DEVELOPMENT APPLICATION

APPLICATION NUMBER:	PLN-25-146
PROPOSED DEVELOPMENT:	Subdivision (Boundary Adjustment)
LOCATION:	1 & 3 Cordelia Court Rosetta
APPLICANT:	Dlc Spatial
ADVERTISING START DATE:	17/10/2025
ADVERTISING EXPIRY DATE:	03/11/2025

RE: Response to Request for Further Information
PLN-25-146 - Boundary Adjustment - 1 Cordelia Court Rosetta.
Our Ref: DLC-541

CLIENT	SCOTT CRIPPS	PROJECT NUMBER	DLC-541
TITLE	PROPOSED LOT DESIGN	REVISION NO:	3
LOCATION	1 CORDELIA CT, ROSETTA TAS 7010	DRAWING NO.	DLC-541-001
		SHEET	1 of 1

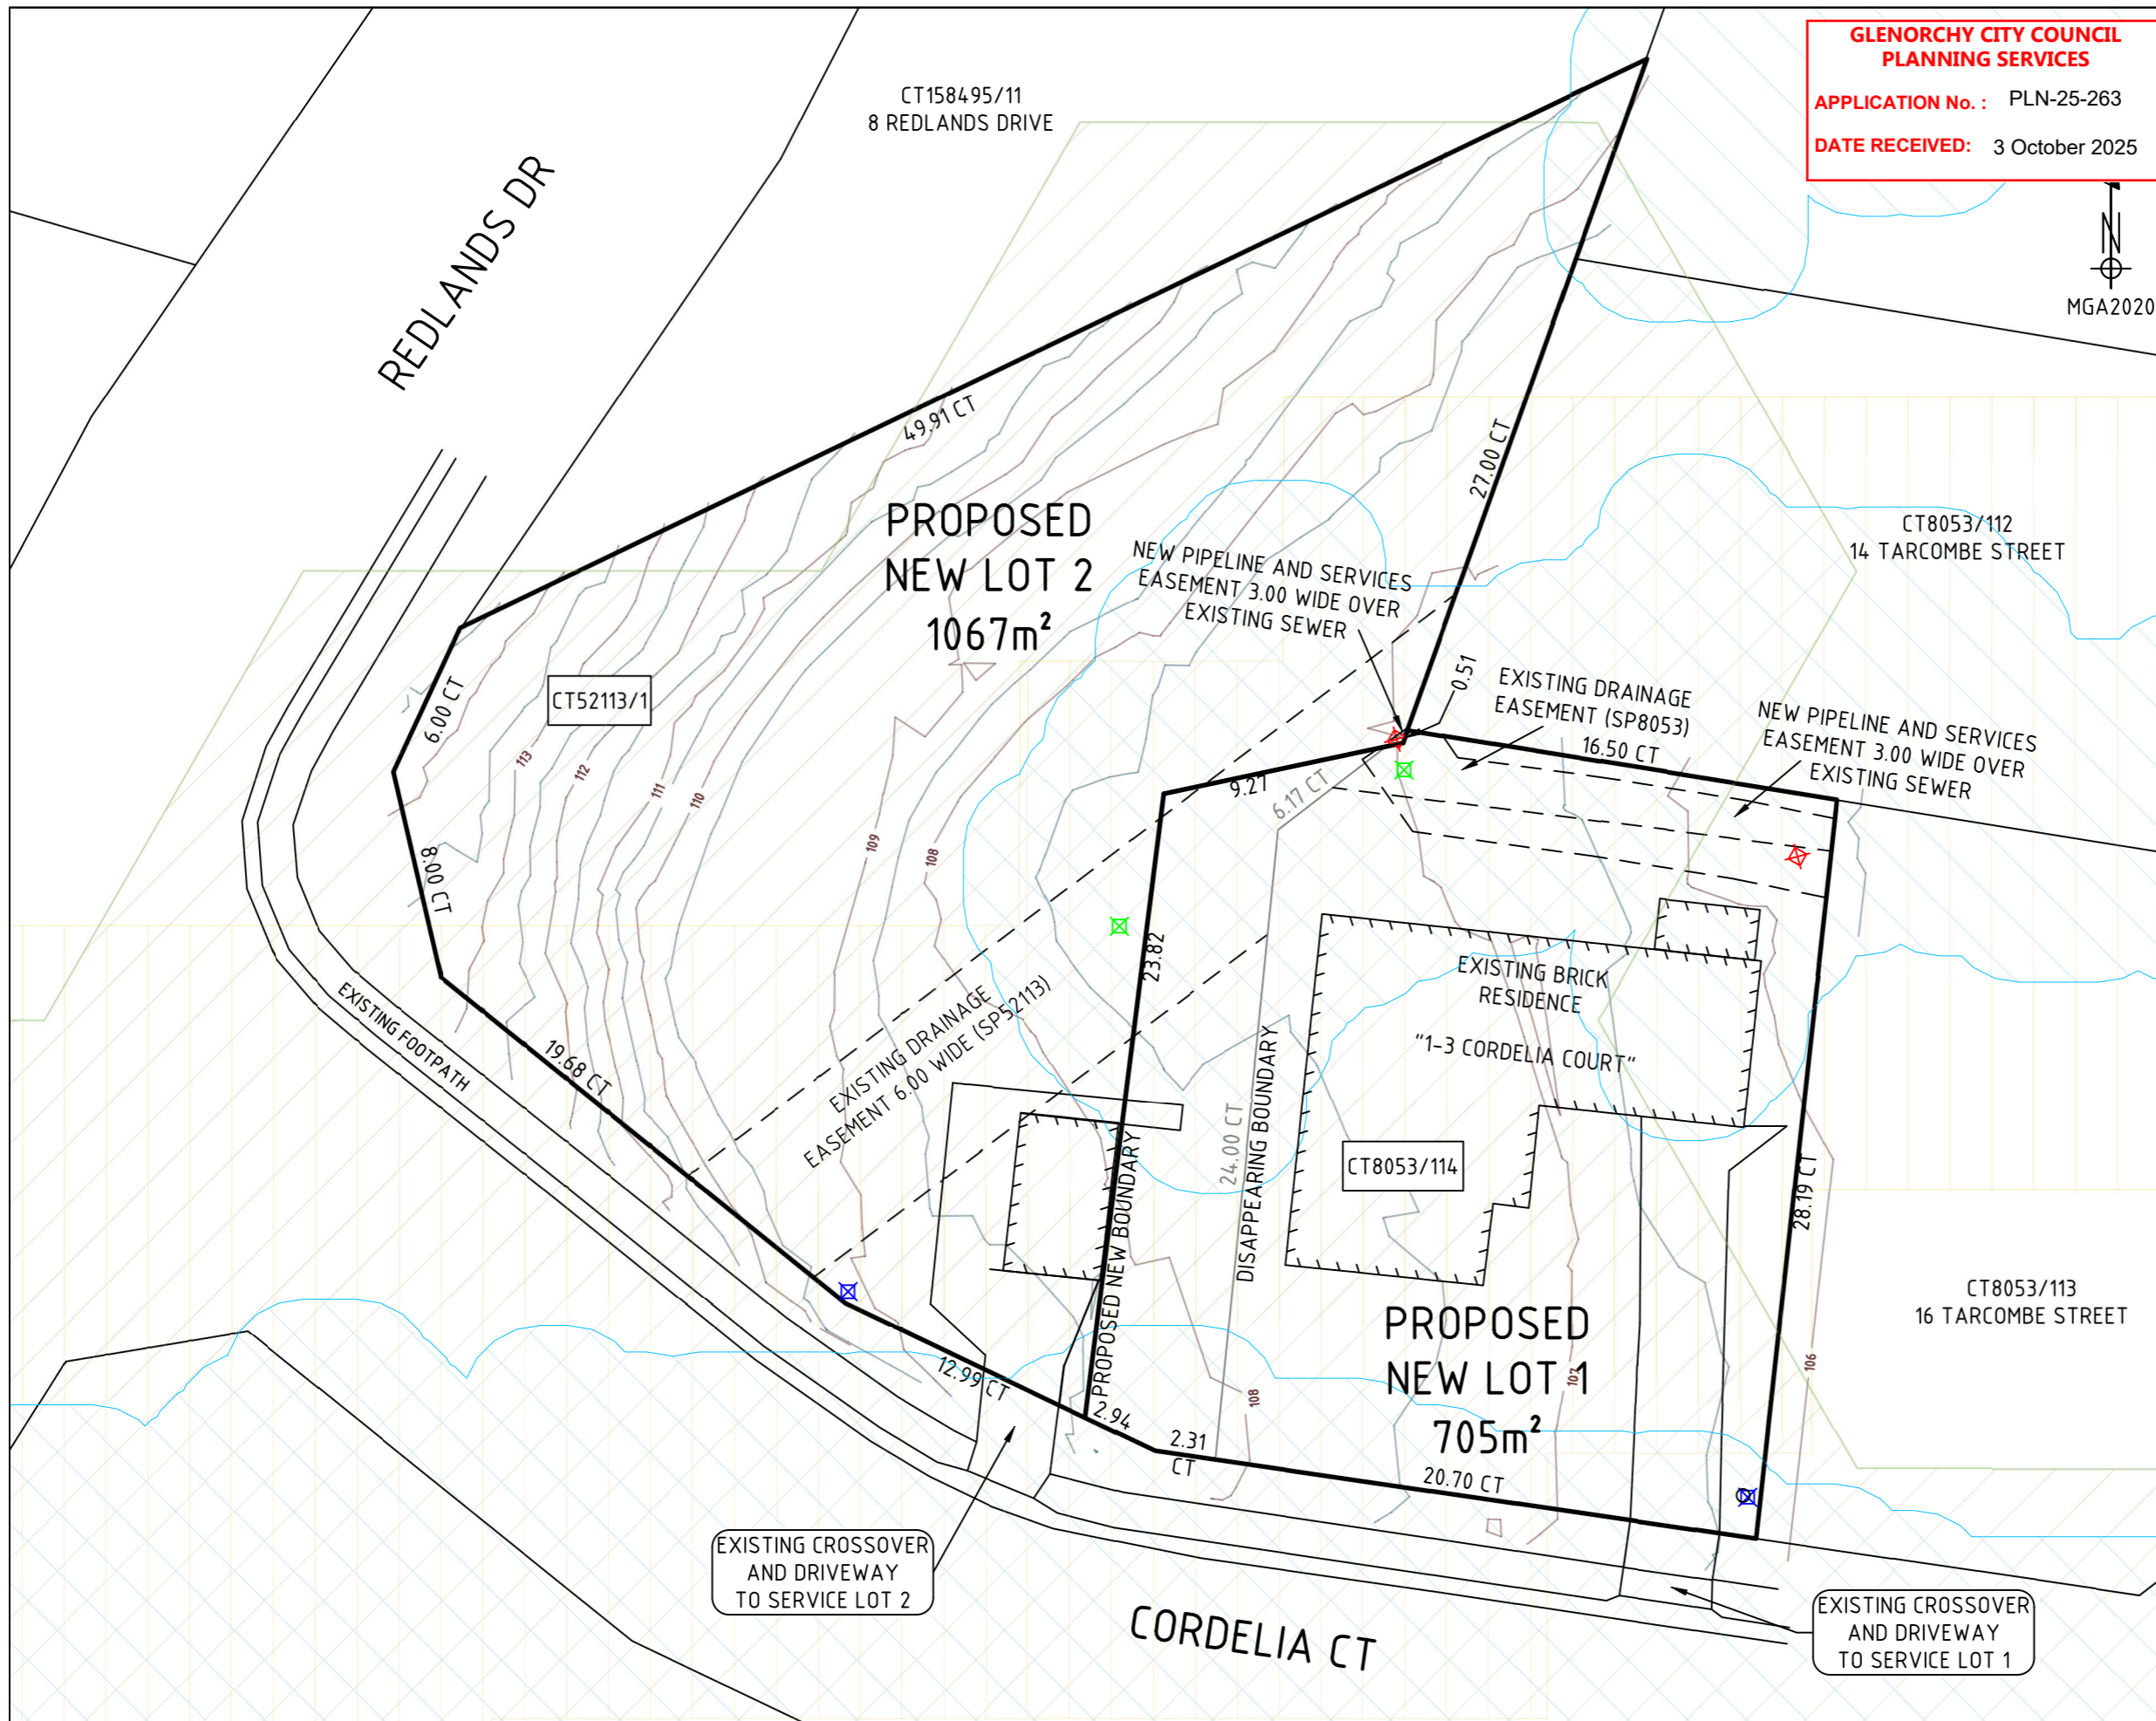
Glenorchy City Council RFI 1 (a) & (b).

Glenorchy City Council RFI 3,4,5,6&7.

Glenorchy City Council RFI 8 & 9.

Taswater RFI 1.

Taswater RFI 2.

Taswater RFI 5.

Taswater RFI 6.

The lot design has been amended so that both proposed lots will utilise their existing, previously approved access arrangements. As a result, no new driveway construction or right of way easement is required. The amended layout is shown on Drawing **DLC-541-001 Proposed Lot Design - Revision 3**.

The lot design has been amended so that both proposed lots will utilise their existing, previously approved access arrangements. As a result, no new driveway construction is required. The amended layout is shown on Drawing ***DLC-541-001 Proposed Lot Design - Revision 3.***

All Taswater infrastructure is contained within a new PIPELINE & SERVICES EASEMENT 3.00 Wide as shown on drawings ***DLC-541-001 Proposed Lot Design - Revision 3*** & ***DLC-541-002 Existing Services Plan.***

Locations of existing water, sewer and stormwater connections for both lots have been confirmed by survey and are connections are located within the new lot boundaries. See drawing DLC-541-002 Existing Services Plan for more information

CLIENT	SCOTT CRIPPS	PROJECT NUMBER	DLC-541
TITLE	EXISTING SERVICES PLAN	REVISION NO:	0
LOCATION	1 CORDELIA CT, ROSETTA TAS 7010	DRAWING NO.	DLC-541-002
		SHEET	1 of 1

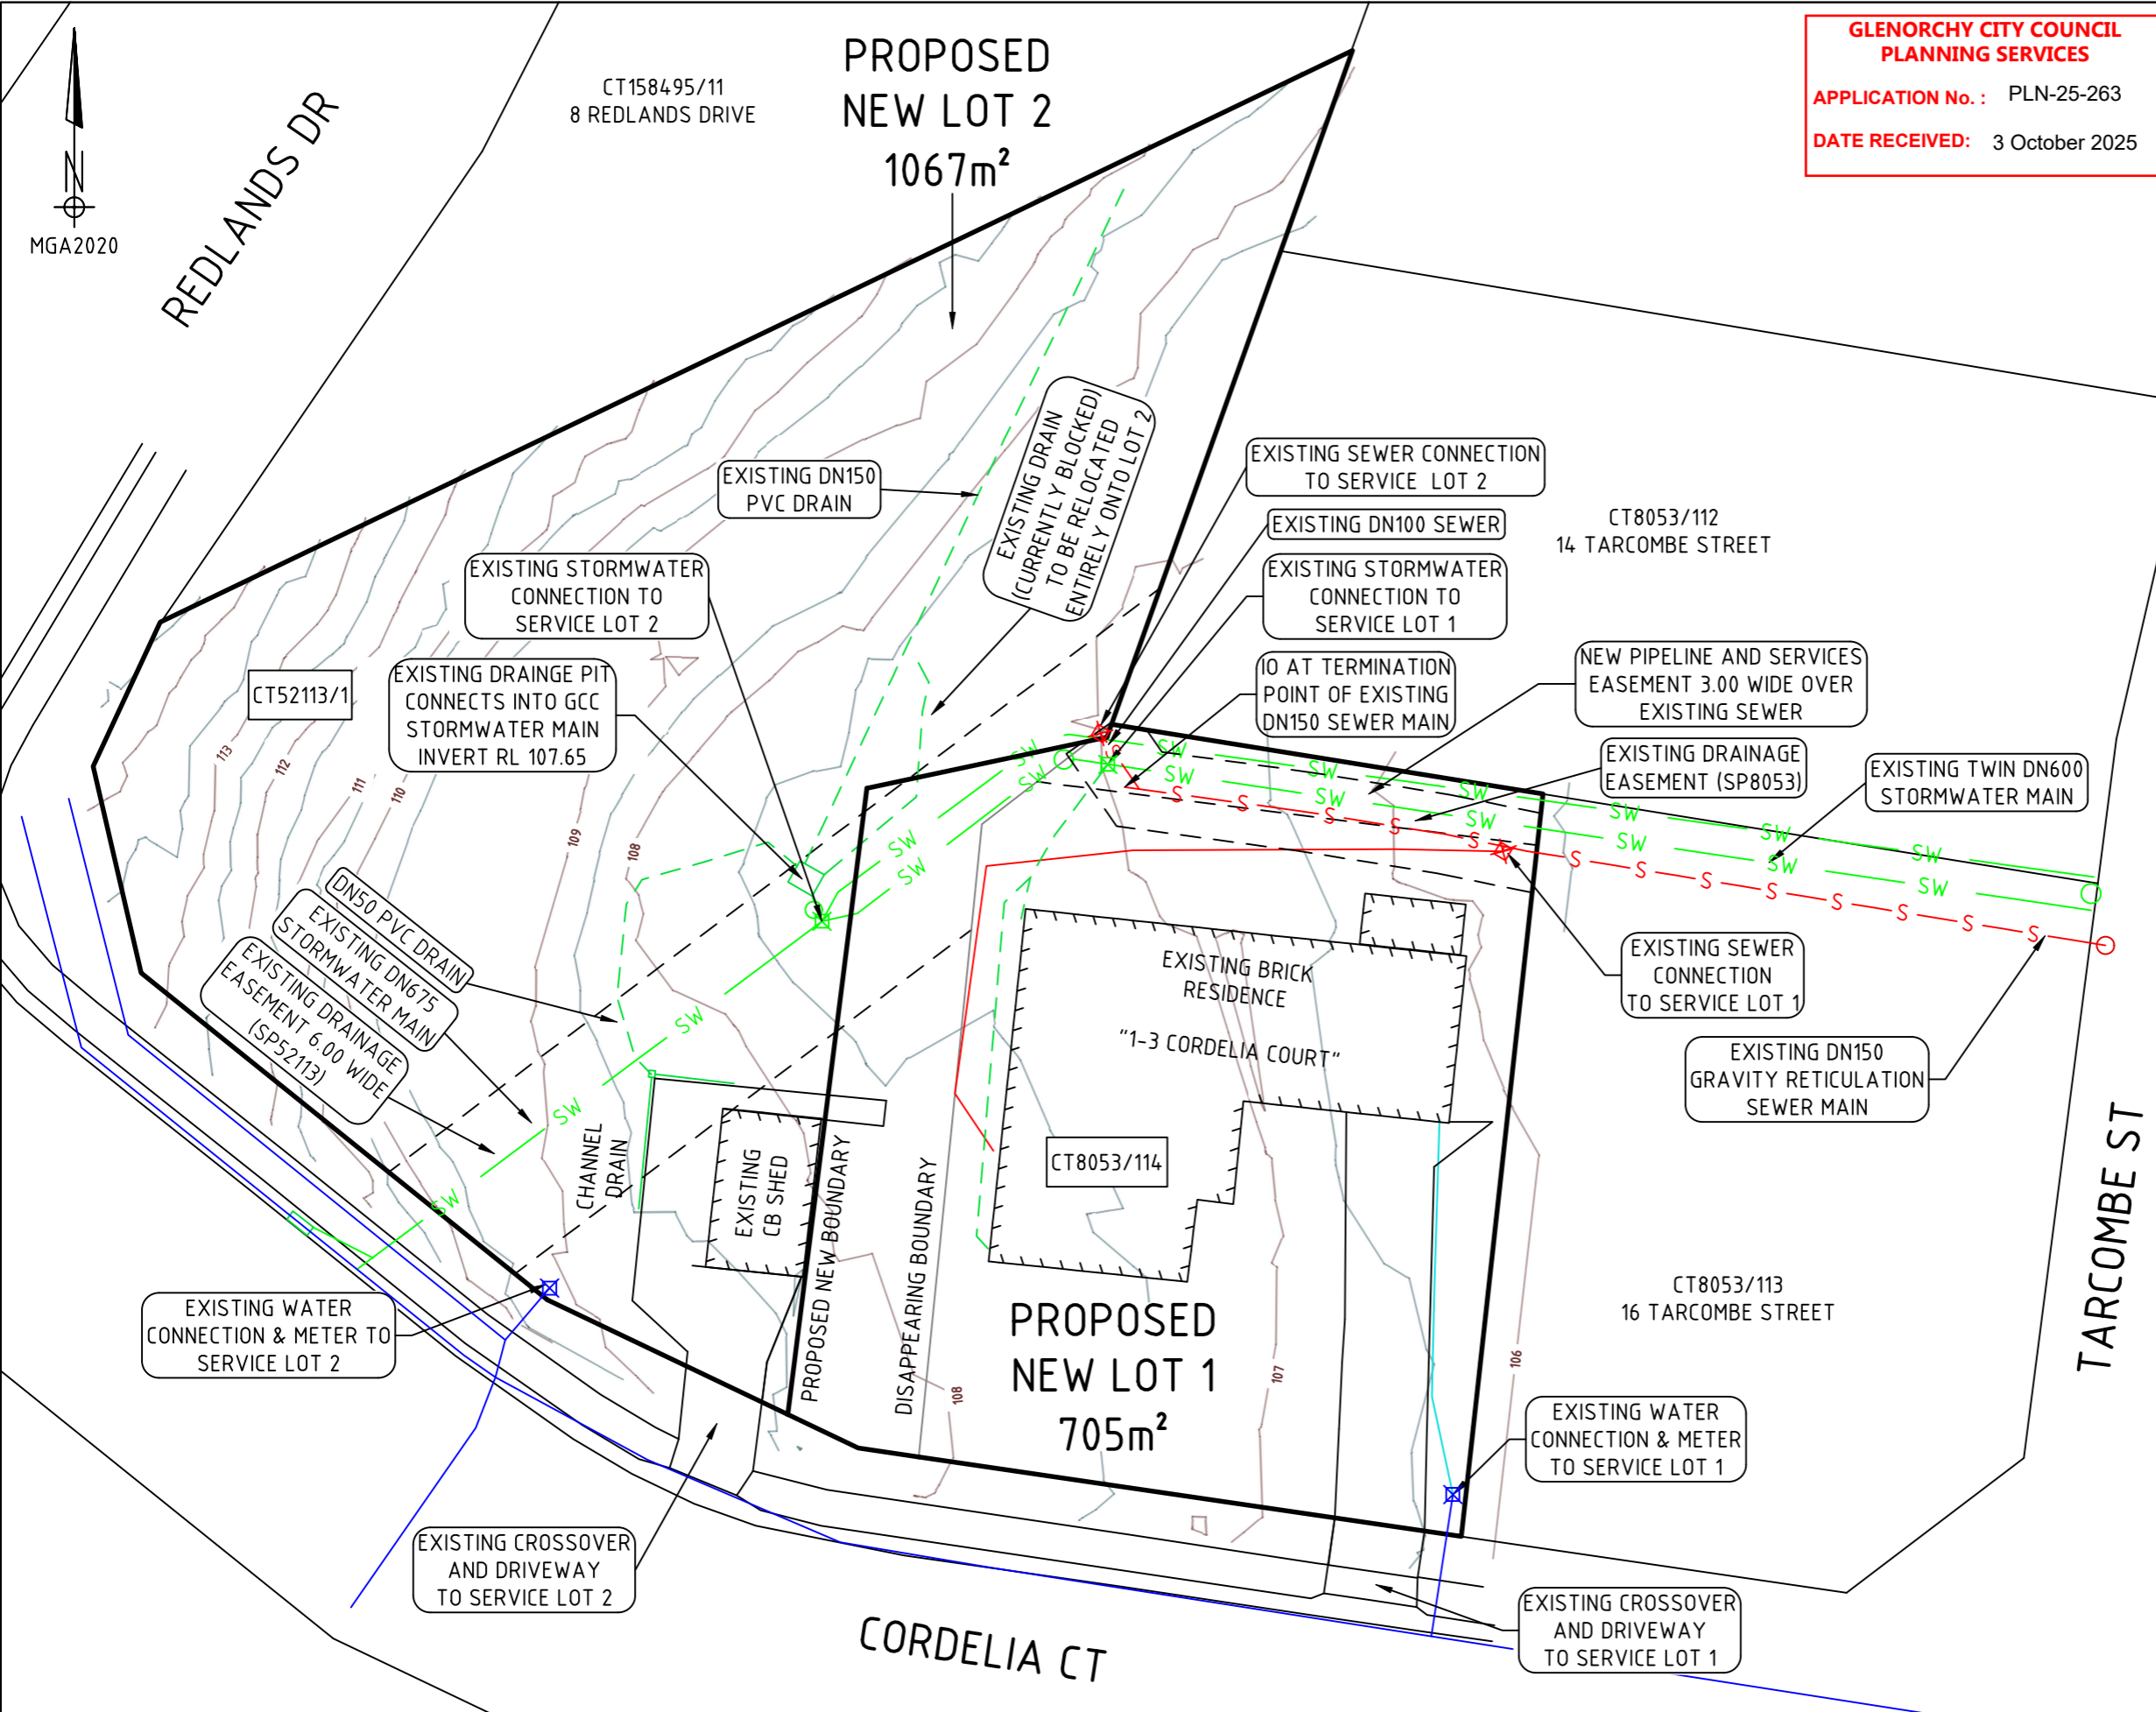
Glenorchy City Council RFI 2.

Taswater RFI 3.

Taswater RFI 7.

Taswater RFI 8.

Taswater RFI 9.

There are two existing stormwater connections located on the site.

- Proposed Lot 1 will continue to utilise the existing stormwater connection currently servicing CT8053/114.
- Proposed Lot 2 will continue to utilise the existing stormwater connection currently servicing CT52113/1.

Accordingly, each lot is provided with a dedicated stormwater connection located entirely on the lot they will be serving, and no new connections or alterations are required.

No new stormwater infrastructure is proposed. See **DLC-541-002 Existing Services Plan**.

The DN150mm diameter sewer main has been located by Archers Underground Services and its surveyed location is included on the plan.

The exact location that the DN150mm sewer main terminates has been identified by Archers Underground Services. The termination point has been physically verified by Non Destructive Digging and is also marked on the surface with an IO. This position is marked on the plan.

As suggested by TasWater in their RFI, Taswater's GIS record in this area appear to be incorrect. No drainage plans were able to be provided for 8 Redlands Drive by Taswater or Glenorchy City Council. It is clear from CCTV footage as well as physical exposure of the sewer infrastructure that 8 Redlands Drive does not utilise the DN150mm sewer main that is located on the land that this development relates to.

Accordingly, each lot is provided with a dedicated sewer and water connections located entirely on the lot they will be serving, and no new connections or alterations are required.

It is noted that TasWater does not have any record of the water connection currently servicing CT52113/1, however this connection has been positively identified on site by The property owner, Archers Underground Services as well as DLC Spatial.

- Proposed Lot 1 will continue to utilise the existing sewer connection currently used by CT8053/114.
- Proposed Lot 2 will utilise the existing additional 100mm sewer connection that is currently located on the boundary between CT8053/114 & CT52113/1 (which was likely installed to service CT52113/1 as part or prior subdivision works). This development application proposes adjusting the location of the boundary in the vicinity of this connection by around 200mm which will ensure that the sewer connection is located entirely on Proposed Lot 2. This connection is currently capped off and not in use.

Accordingly, each lot is already provided with a dedicated sewer connection located entirely on the lot they will be serving, and no new connections or alterations are required.
